NSW Independent  
Planning  
Commission

Pitt Street South  
OSD

INTERNAL AMENITY  
SUBMISSION

18 March 2021  
Final

# SOLID / GLASS RATIO

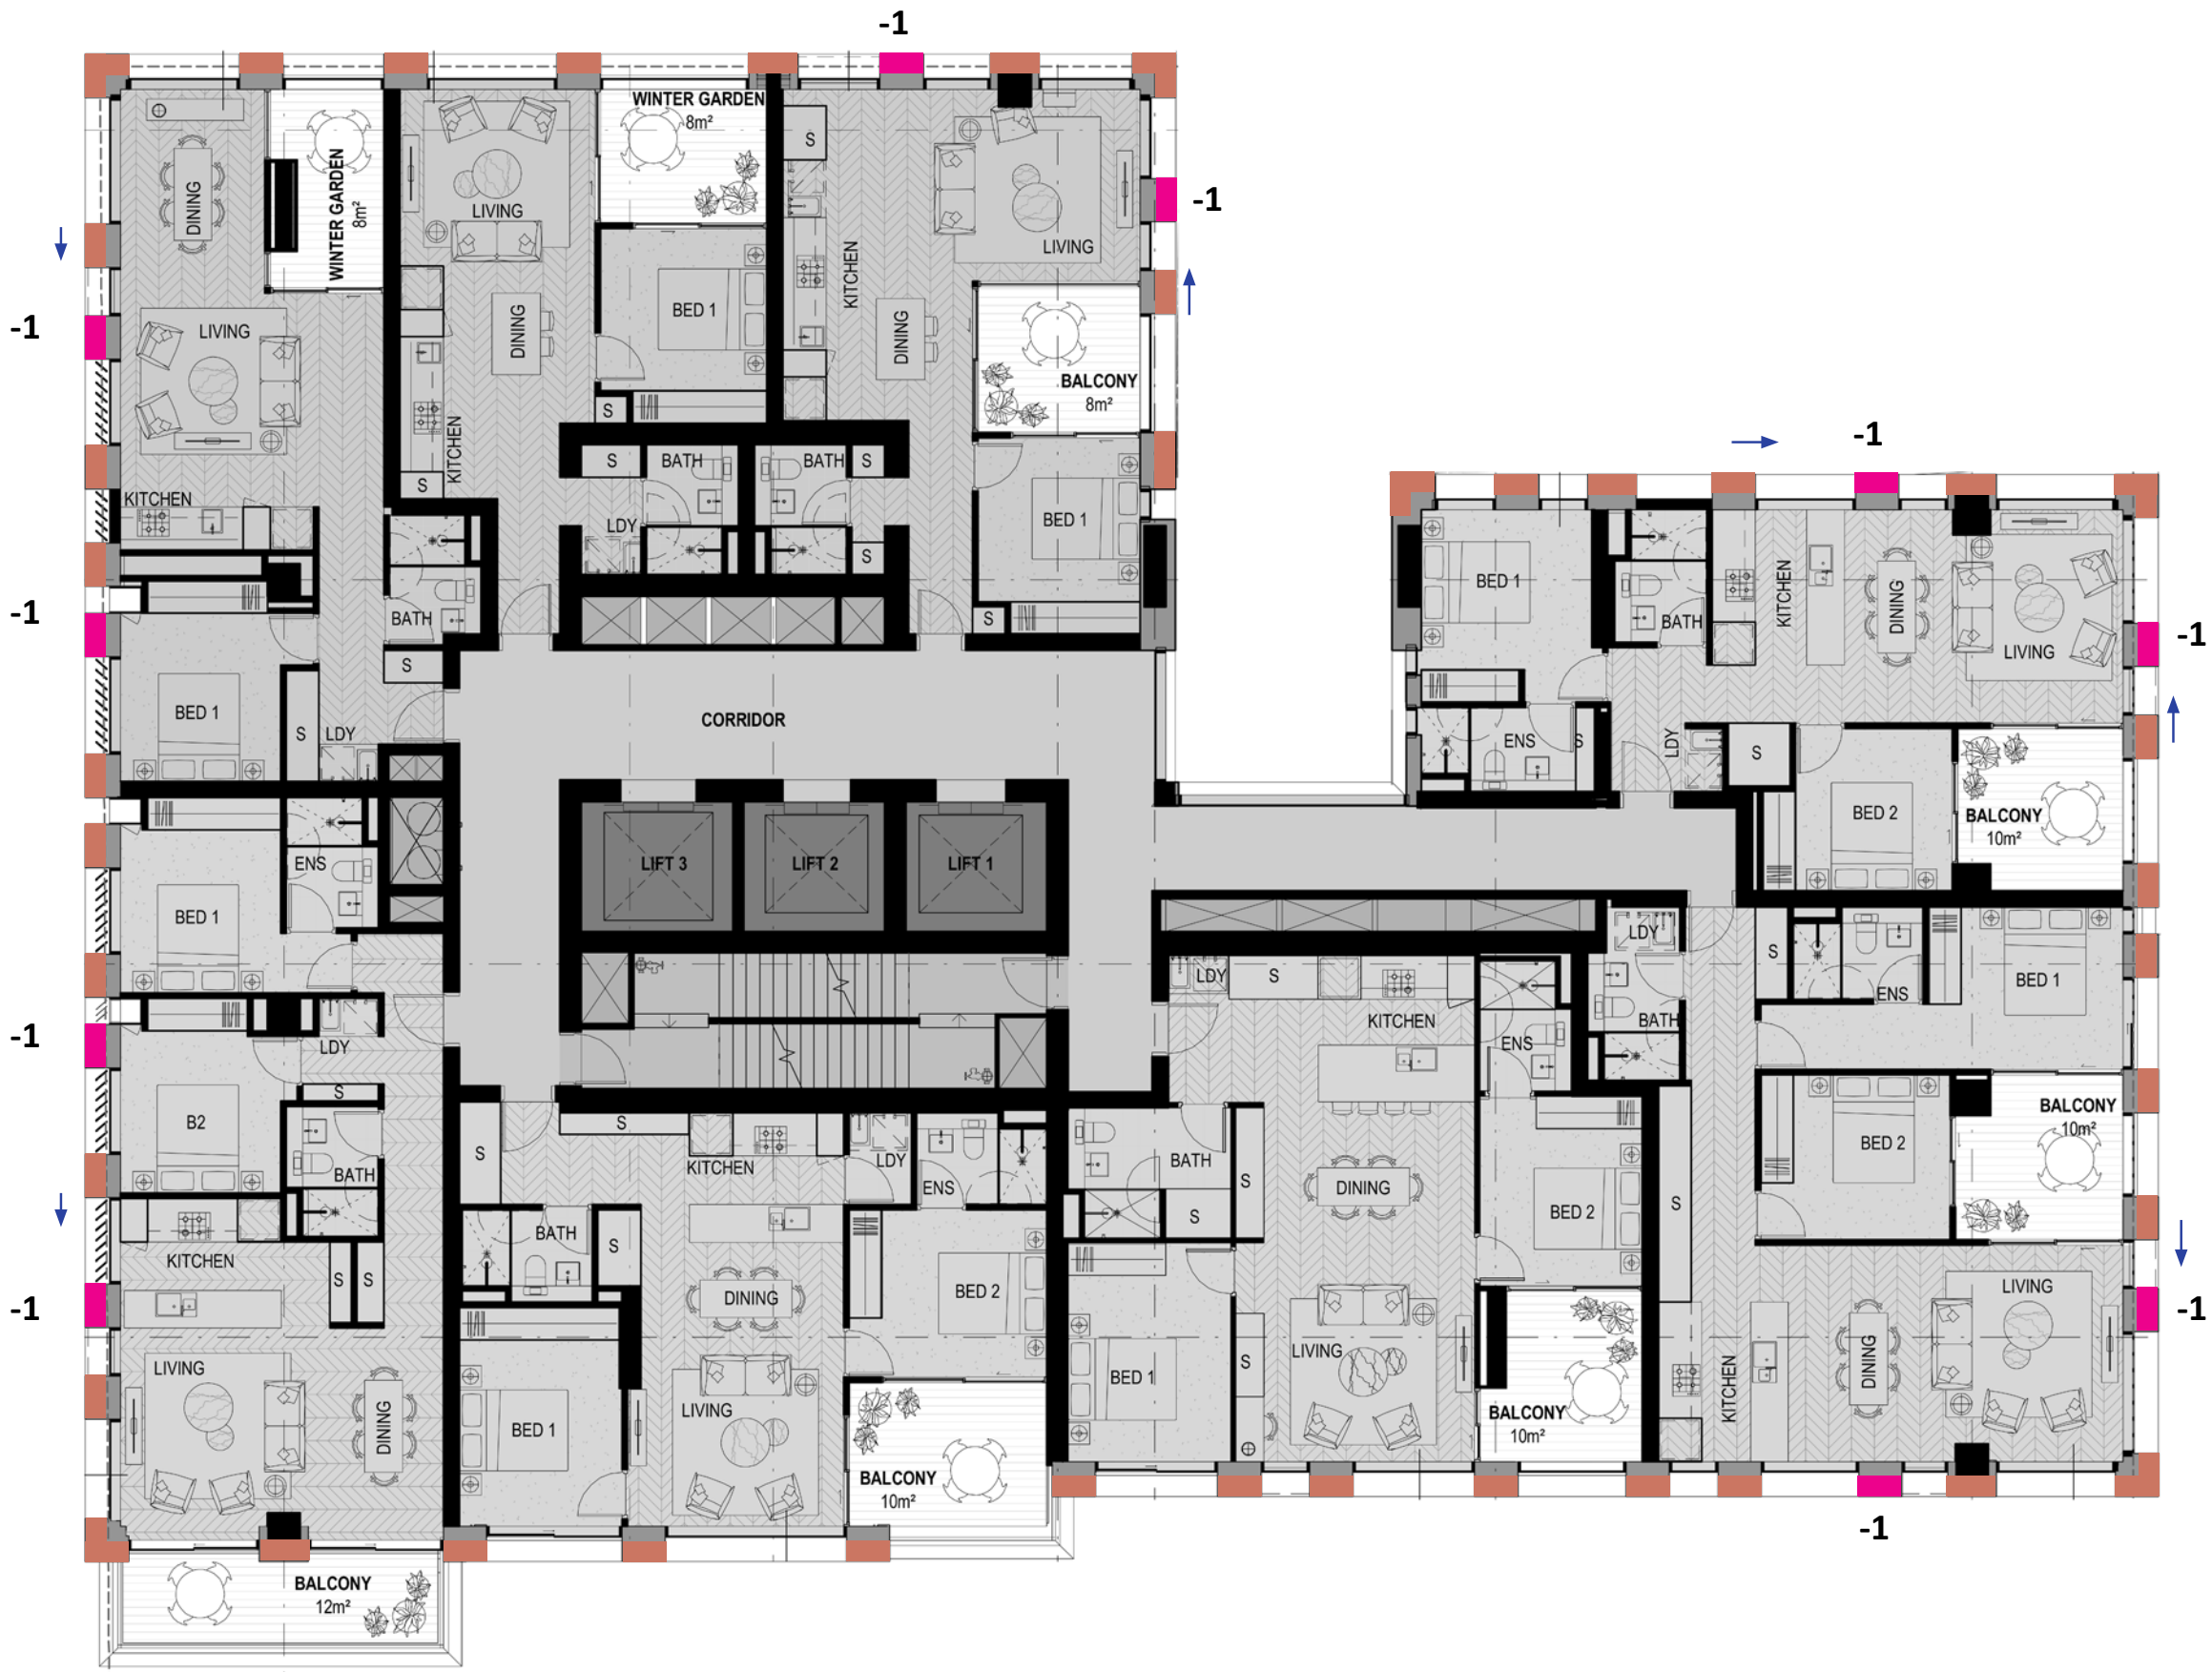
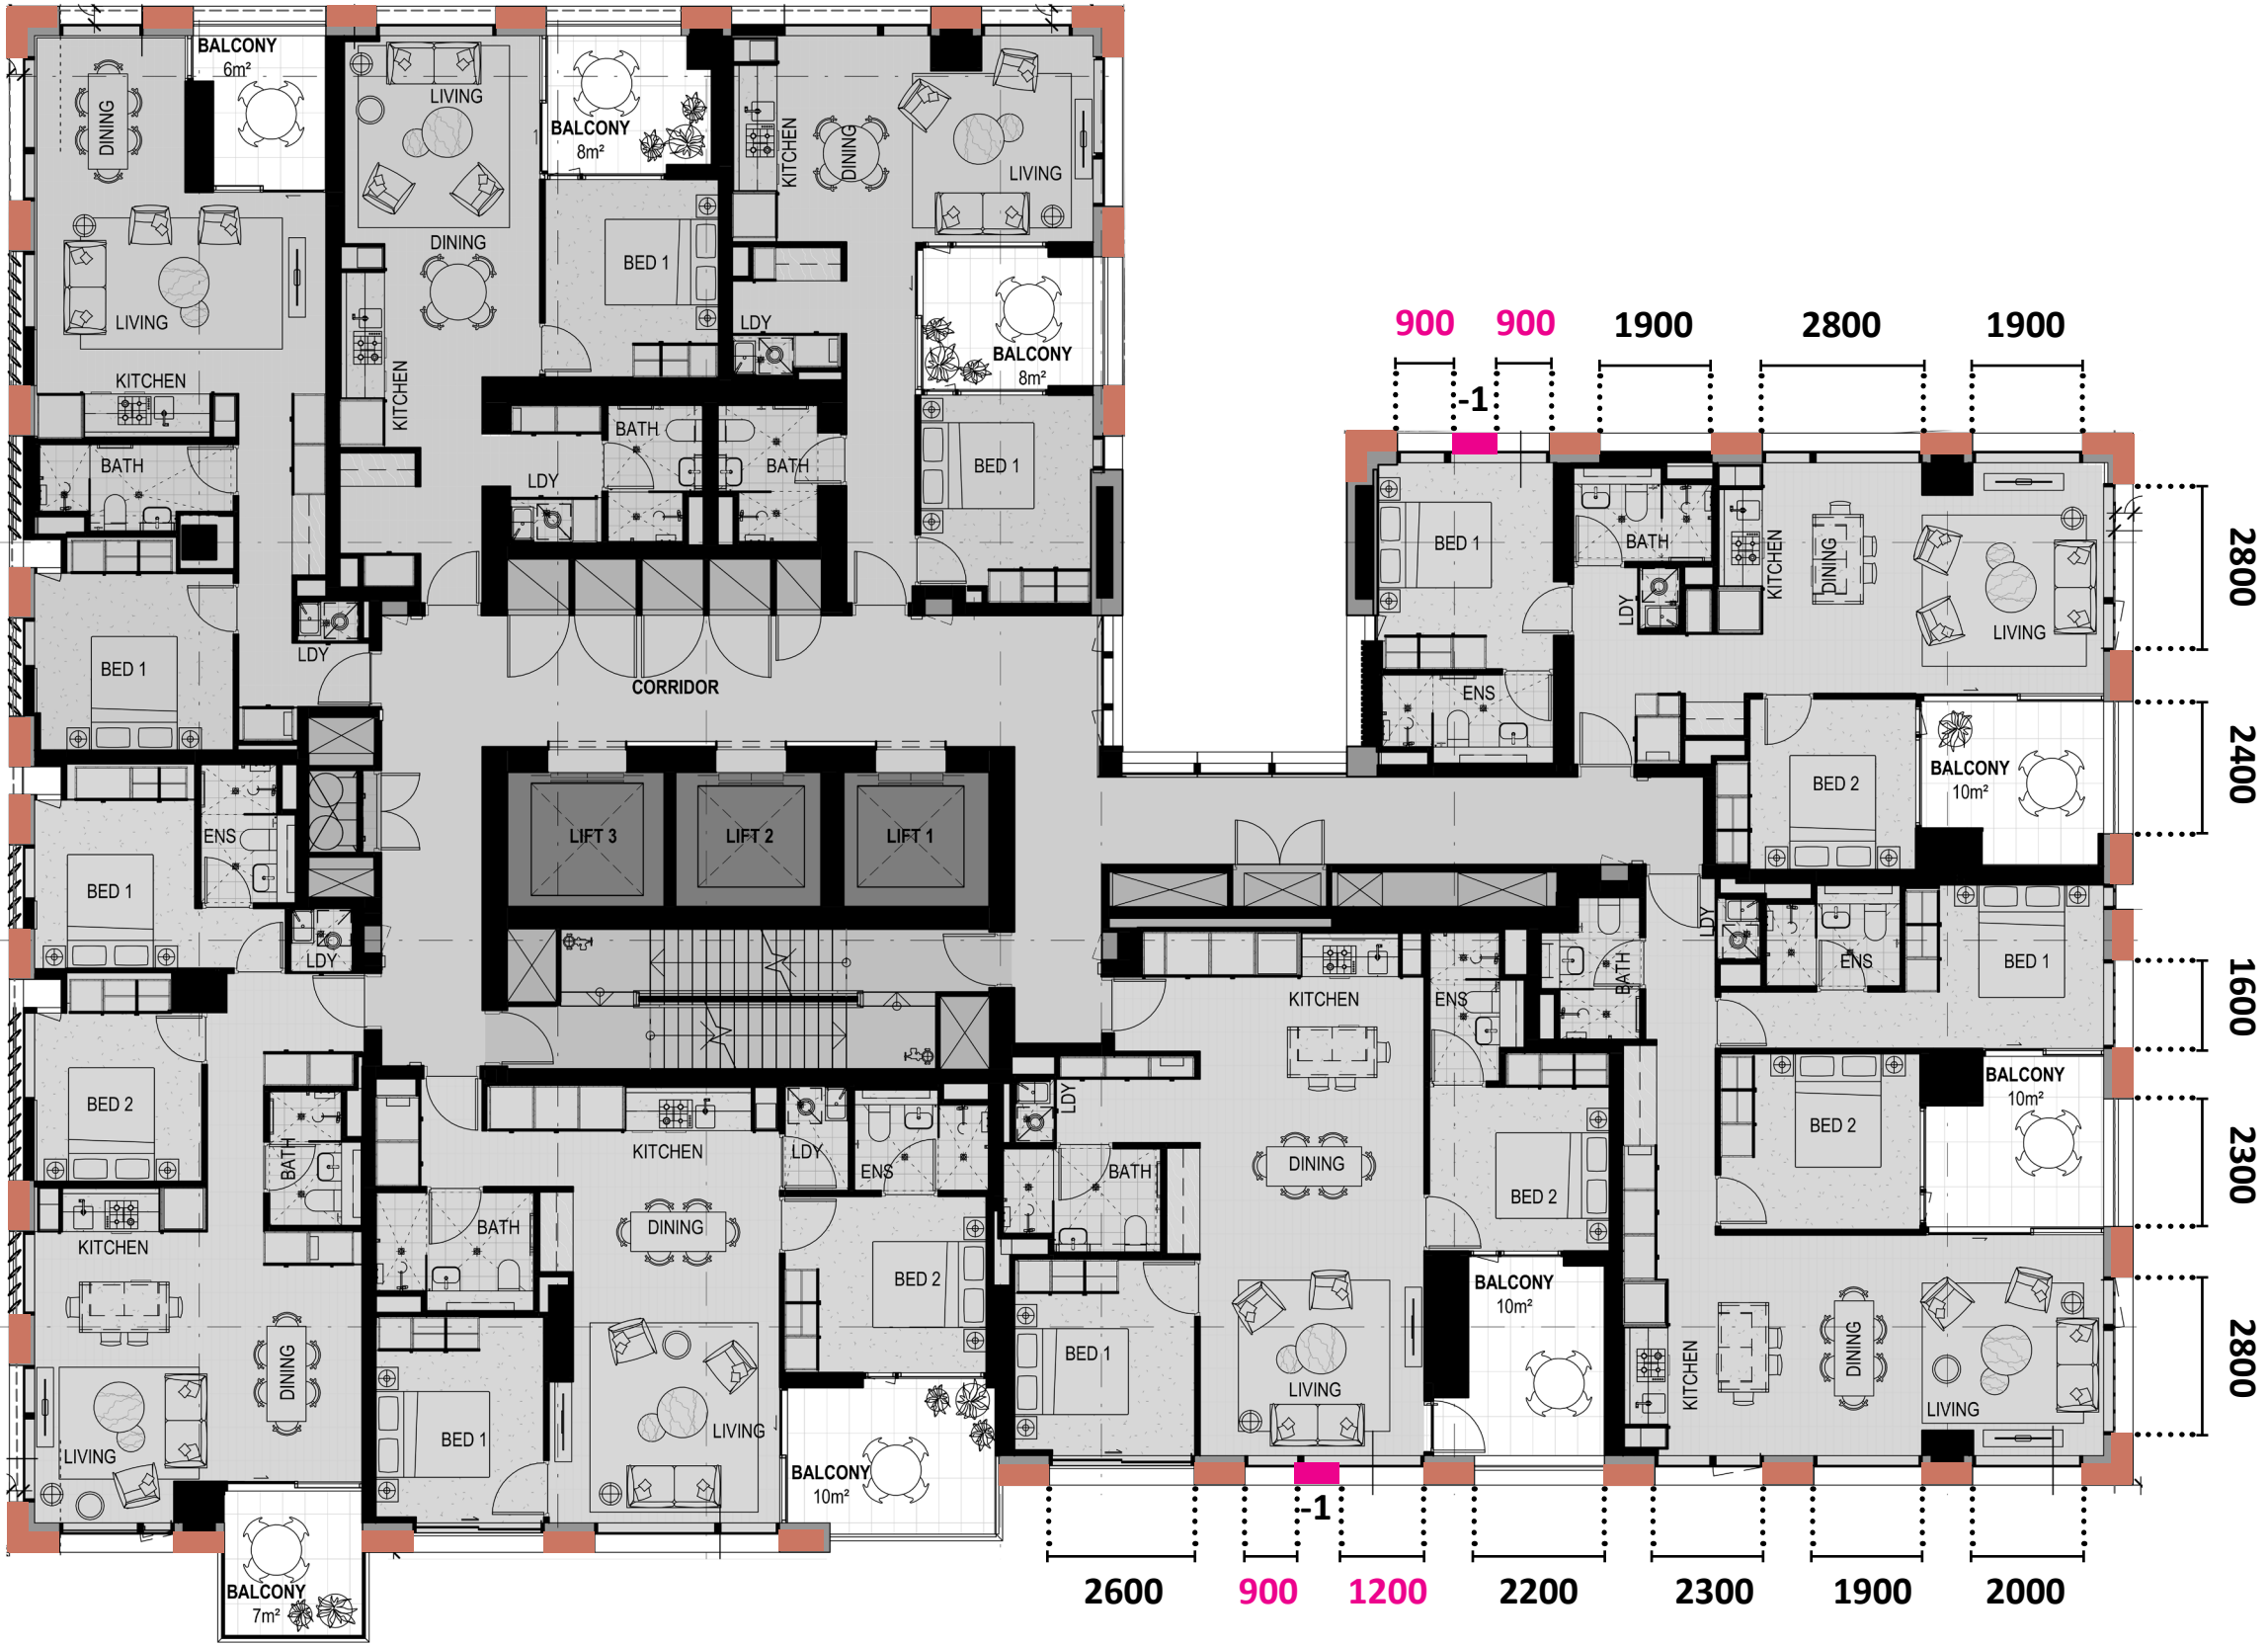
The Panel requests an urgent comparative analysis (of % of solid vs glazing) is provided of the Stage 2 DA façade vs the current proposed façade, prior to resubmission – in order to ascertain the overall impact. The comparative analysis should consist of elevations, plans and 3d views.

*The Panel requests an urgent **comparative analysis (of % of solid vs glazing)** is provided of the Stage 2 DA façade vs the current proposed façade, prior to resubmission – in order to ascertain the overall impact. The comparative analysis should consist of elevations, plans and 3d views.*

At DRP #12, All solid elements were increased to 900mm wide and 10 solid elements were proposed to be removed resulting in a total of **41 solid elements** (excluding lightwell):

Two additional solid panels were removed to even up the spacing between verticals, resulting in a total of **39 solid elements** (excluding lightwell). To avoid an increase in glazed area, we amended the GRC to Facade fixing, removing the 50mm fixing zone gap and offsetting the mullion to either side. This eliminated a gap with visible fixings and also reducing the glazed area by a further 50mm either side of the 900 wide GRC element.

As per DRP #13 plan with **39 solid elements** but with 400mm deep GRC as opposed to 325mm deep.

SSDA:	DRP #12:	DRP #13:	PROPOSED:
SOLIDS PER FLOOR:	51	41	39	39
GRC WIDTH P/ELEMENT:	800 / 900	900	900	900
SOLID WIDTH P/ELEMENT:	800 / 900	900	900	900
GRC DEPTH:	400mm	250mm	325mm	400mm
EXTERNAL FACADE DEPTH:	450mm	300mm	325mm	450mm
TOTAL LENGTH SOLID:	46.1m	42.3m	40.2m	40.2m
TOTAL LENGTH GLASS:	83.6m	87.2m	89.3m	89.3m
GLASS TO SOLID RATIO:	1.81 : 1	2.06 : 1	2.22 : 1	2.22 : 1
PERCENTAGE OF SOLID:	35%	33%	31%	31%
